**Applicant requests a Special Exception from Section 2.16.050 K (Carport over a Driveway) in an R-5 (Residential) zone.**

### MEMORANDUM

SUBJECT: CARPORT CASE FOR July 28, 2008 ZBA MEETING

I have reviewed the plans for ZBA case 08-00058 located at 12008 Sal Rasura. The applicant is requesting a Special K Exception under Title 2.16.050 for a carport over the driveway.

SITE PLAN

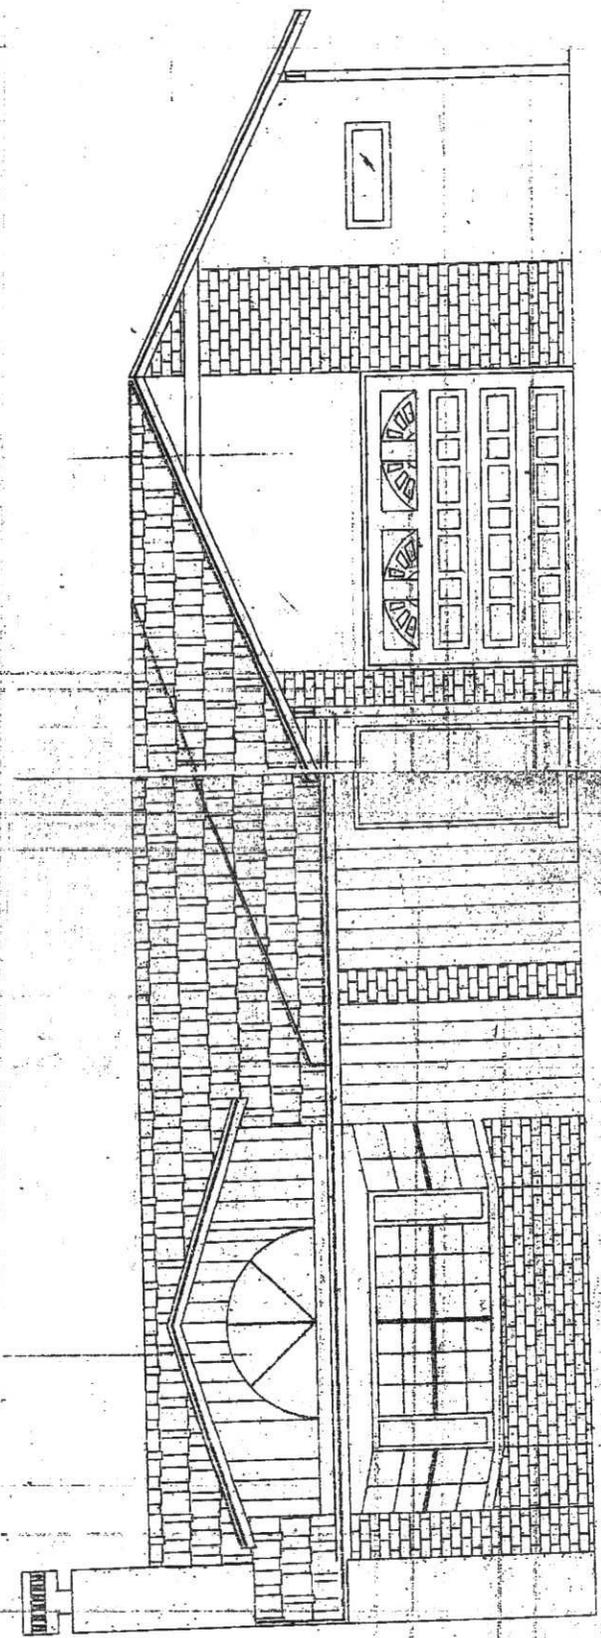
This would permit the existence of a 24' by 14' carport proposed to encroach 14' into the required front yard setback.

Required front yard setback = 20'

Requested front yard setback = 6'

FRONT ELEVATION SCALE: 3/8" = 1'-0"

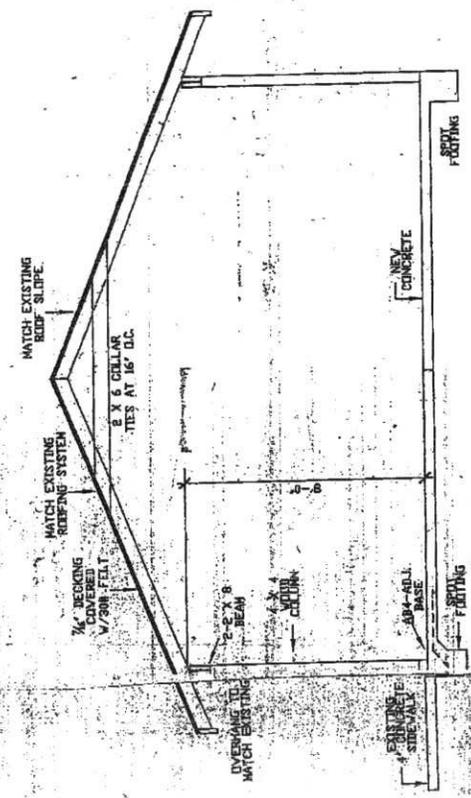
1. The carport is structurally unacceptable and unsafe, encroaching in the required 5' side yard setback, and higher than the roof line of the house.
2. Due to the extensive problems with the existing structure, the only remedial action is to obtain a demolition permit and take down the carport.
3. His submitted plans have been reviewed by Building Permits & Inspections and determined to be structurally unacceptable.
4. If he continues with his request for a carport, he will need to submit revised plans that meet the building code and ZBA requirements. If his revised plans show an encroachment within the 5' utility easement at the front of the property, he will need to provide letters from the utility companies that allow him to build within the easement.

The carport's structural design has been reviewed and has been found to be not acceptable due to the following;

1. Unsafe structure, missing support beams
2. Encroaching with support post into side property.
